City of Surrey
PLANNING & DEVELOPMENT REPORT

File: 7912-0106-00

Planning Report Date: July 9, 2012

<i>File No.:</i>	7912-0106-00
<i>New or Resubmit:</i>	Resubmit after workshop
<i>Last Submission Date:</i>	May 17, 2012 (workshop)
<i>Description:</i>	Proposed Guildford Aquatic Centre
<i>Address:</i>	10585-152 St. & 15105-105 Ave., Guildford, Surrey
<i>Developer:</i>	Scott Groves, Manager Civic Facilities, City of Surrey
<i>Architect:</i>	Lisa Potopsingh and Michael Heeney, Bing Thom Architects and Alec Smith, Shape Architects
<i>Landscape Architect:</i>	Derek Lee, PWL
<i>Planner:</i>	Pat Lau
<i>Urban Design Planner:</i>	Tom Ainscough and Mary Beth Rondeau

3.11 Rainwater Management

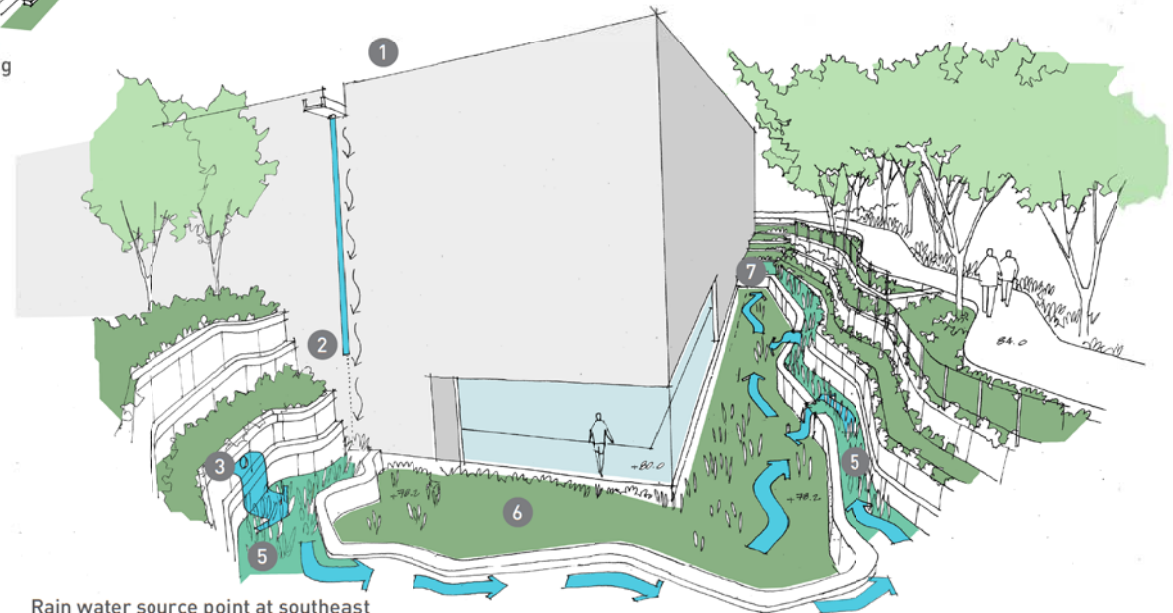
- In the lower detention area, should use lower plant types that will not require continuous maintenance, e.g., yellow and red twig dogwood may grow large and block views.

The bottom elevation of the stormwater detention area has been lowered from the floor elevation of the pool in order to improve sightlines over shrub planting. It is anticipated that the selected shrub pieces including the red and yellow dogwood will not exceed heights of 1.5 metres (5ft.) and therefore, will reach an appropriate height over the rain garden, allowing for clear views to the stormwater detention channel.

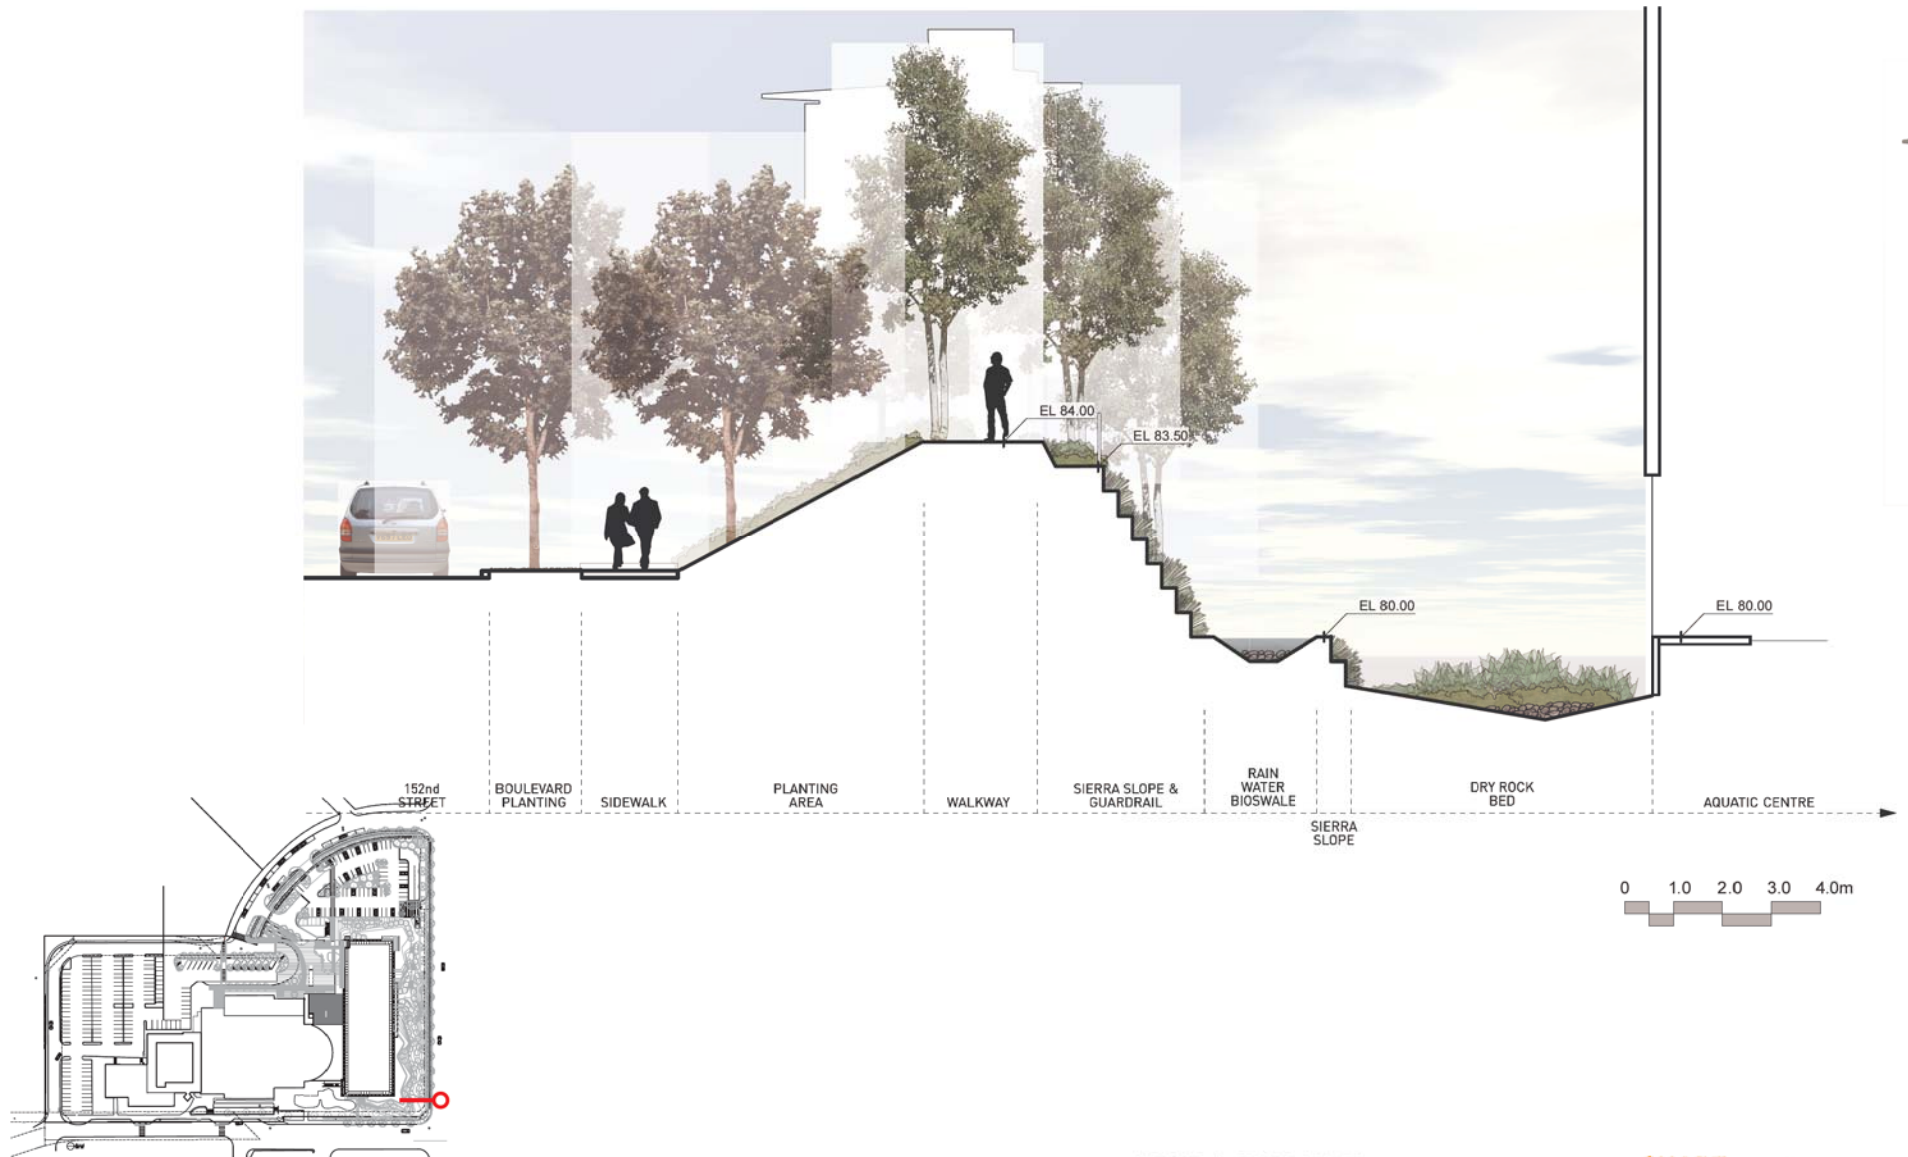
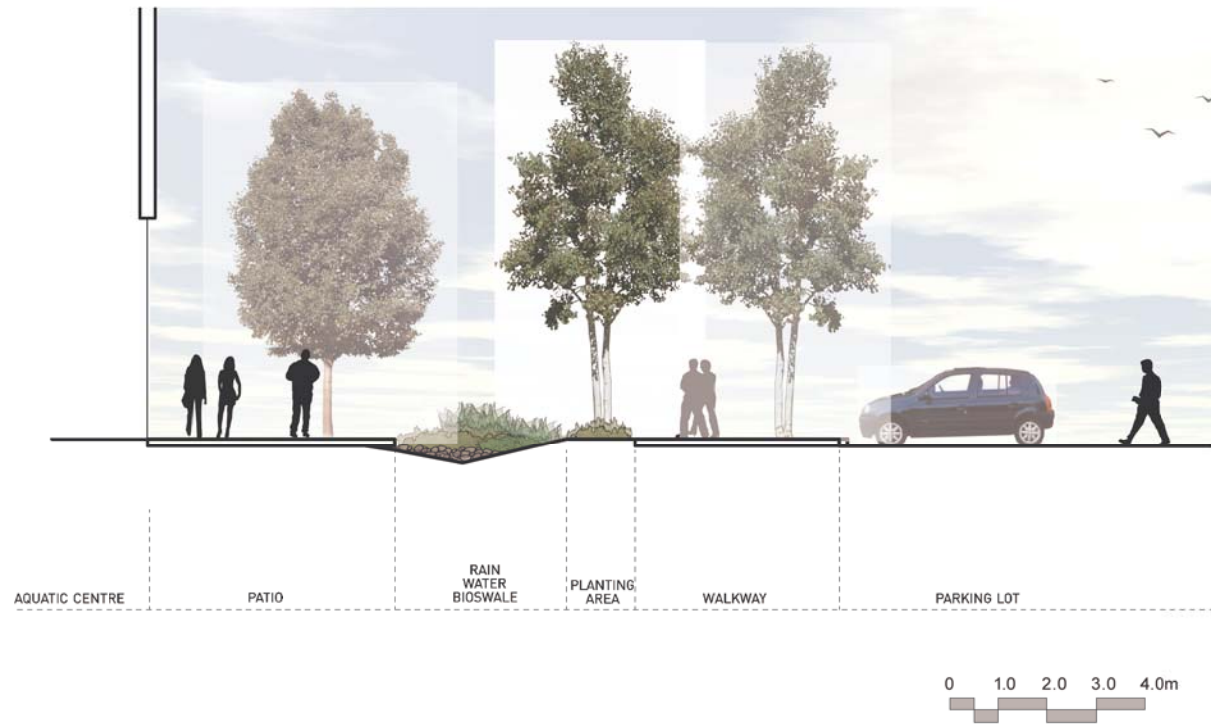
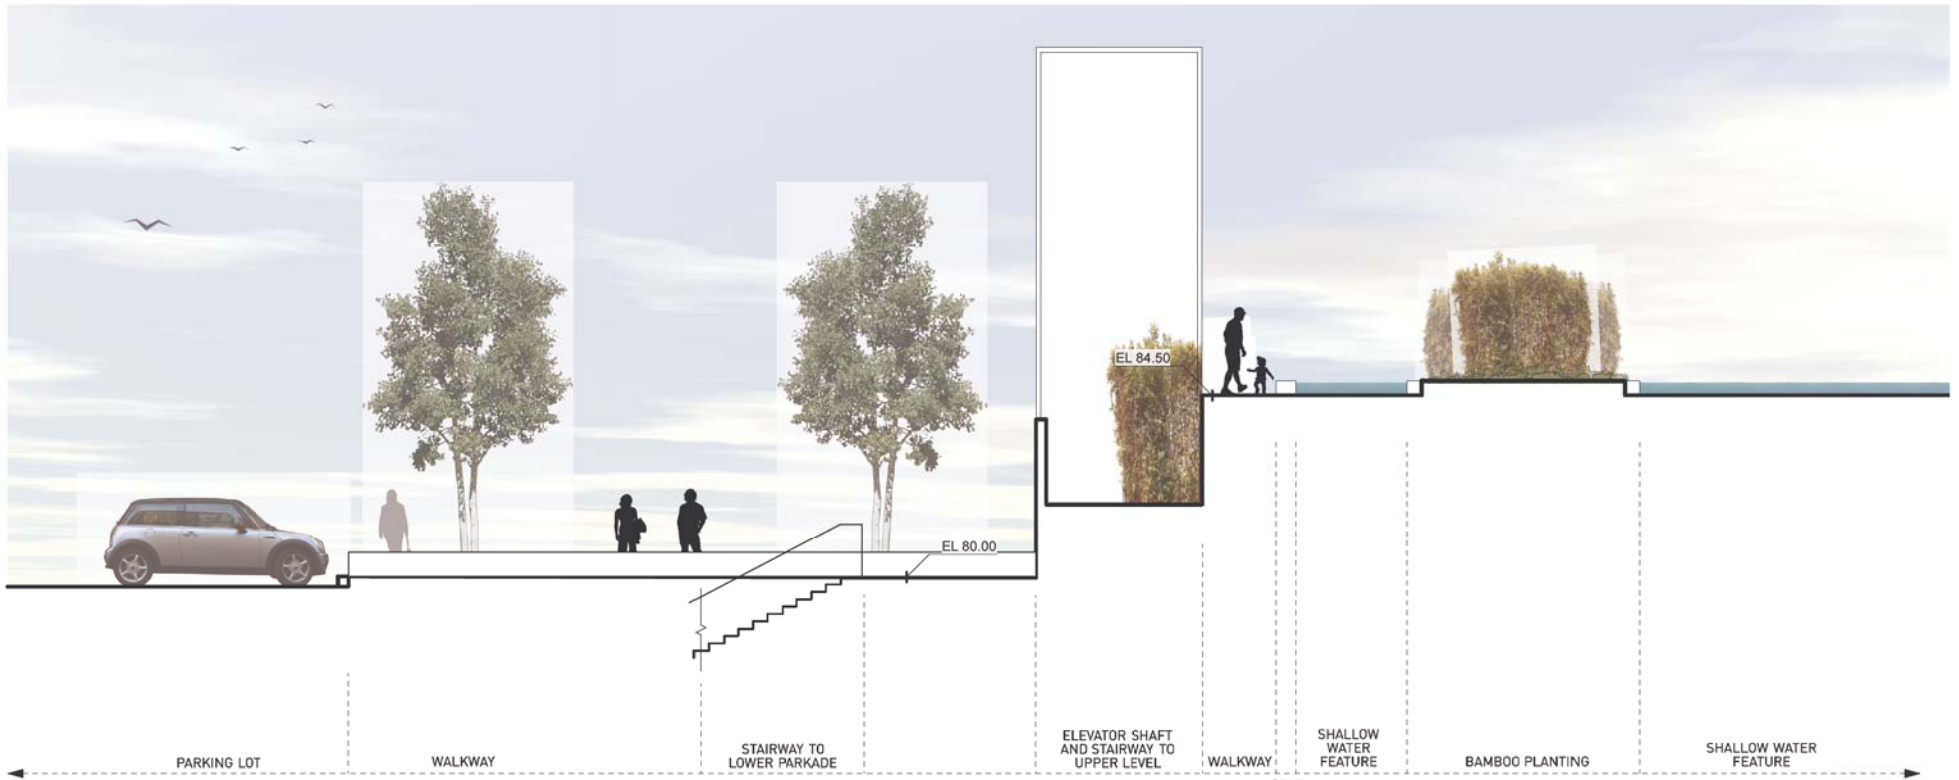
- Consider detail of connection between building wall and landscaped retaining wall at 152 Street at entrance; current systems may collide a bit awkwardly; see page 26.

The project architect's intent is that this will be detailed, so that over time, the sierra wall or gabion wall will be overgrown with planting and will recede in the background.
